BROOKHAVEN NATIONAL LABORATORY
ASSOCIATED UNIVERSITIES, INC.

August 11, 1980

Mr. Patrick Sears
Chemical Engineering
U.S. Nuclear Regulatory Commission
Washington, D.C. 20555

TO: R.E. Hall
BoS w/ster
FROM: R.O. Smith and E.A. MacDougall *E.A. MacDougall*
SUBJECT: Trip Report - Meeting at Duke Power
Company, Charlotte, NC

FIGURE 4: The History of Static Pressure Developed From Room Fire Tests with a Range of Fuel Loads³

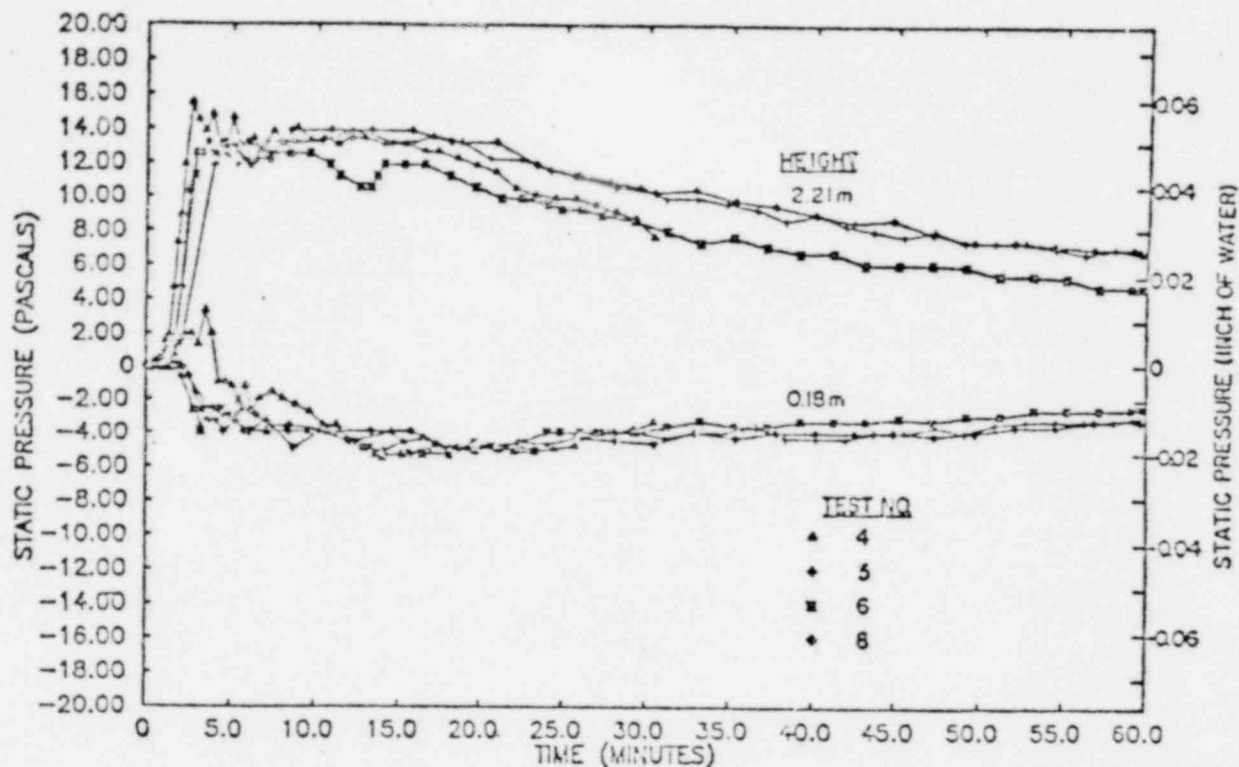
These experiments show:

- A. *There is a positive pressure developed in the upper part of the room and a negative pressure at the bottom,*
FURTHERMORE
- B. *A value of 12.5 Pa (0.05 inches of water) is a good approximation for the pressure in the post-flashover portion of the fire.*

It is my recommendation that a positive pressure of 12.5 Pa (0.05 inches of water) be established as the standard pressure to be used in the subject fire test at the top of the furnace. Furthermore, I recommend that the neutral plane be kept between 1/3 and 1/2 of the height of a vertical test specimen.
